SUBJECT: Forwards response to Geosciences Branch 811201 questions.  
 Response include addl question & two amended questions. All  
 answers will be included in Amend 23 to FGAR.

Subject: NUCLEAR PROJECT NO. 2  
GEOSCIENCES BRANCH QUESTIONS

These responses will be included in Amendment 23 to the WNP-2 FSAR.

FIGURE  
3.6-41b

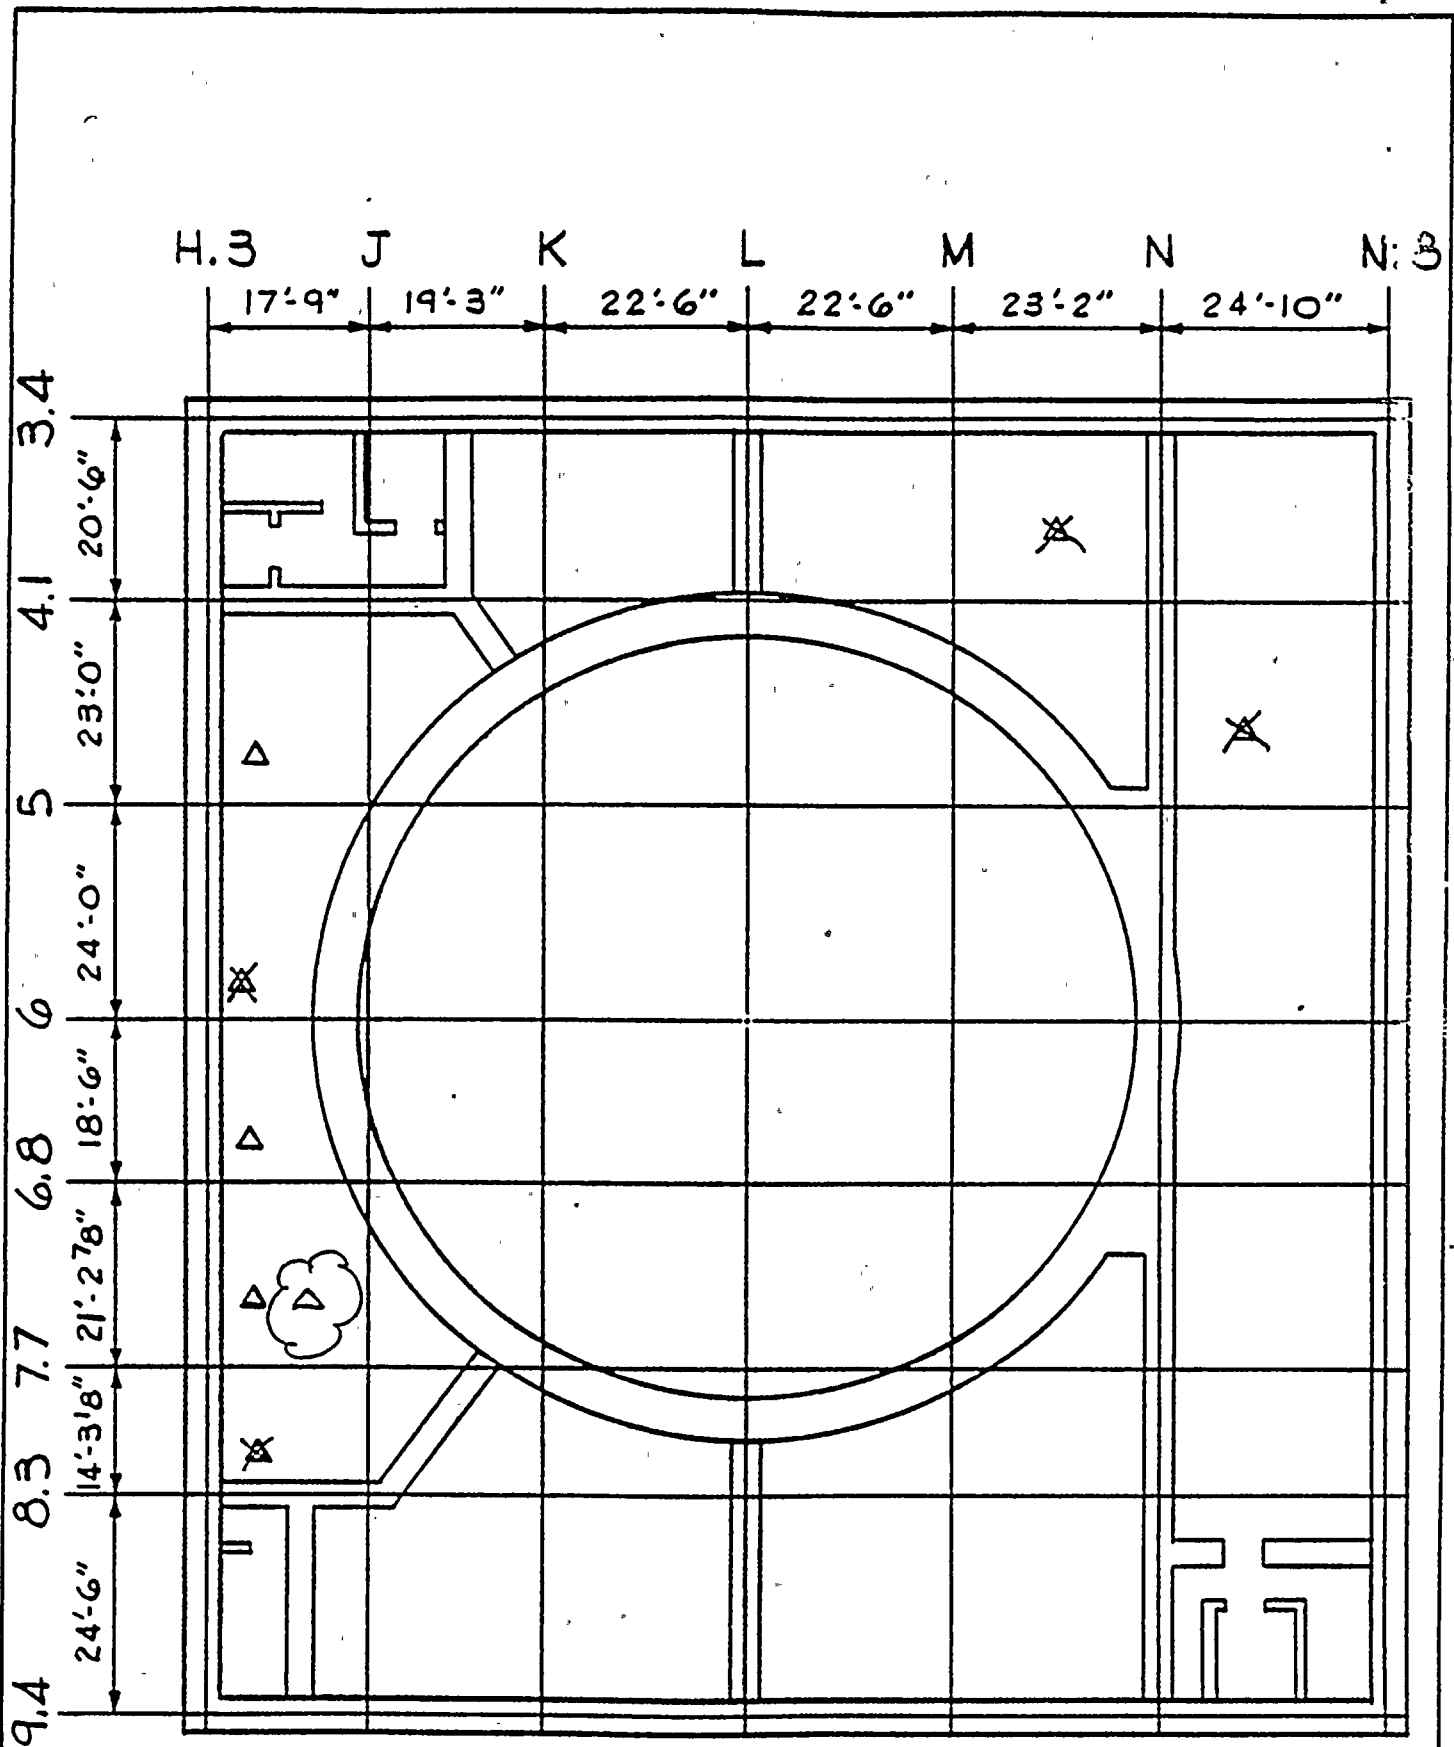
Revise as shown
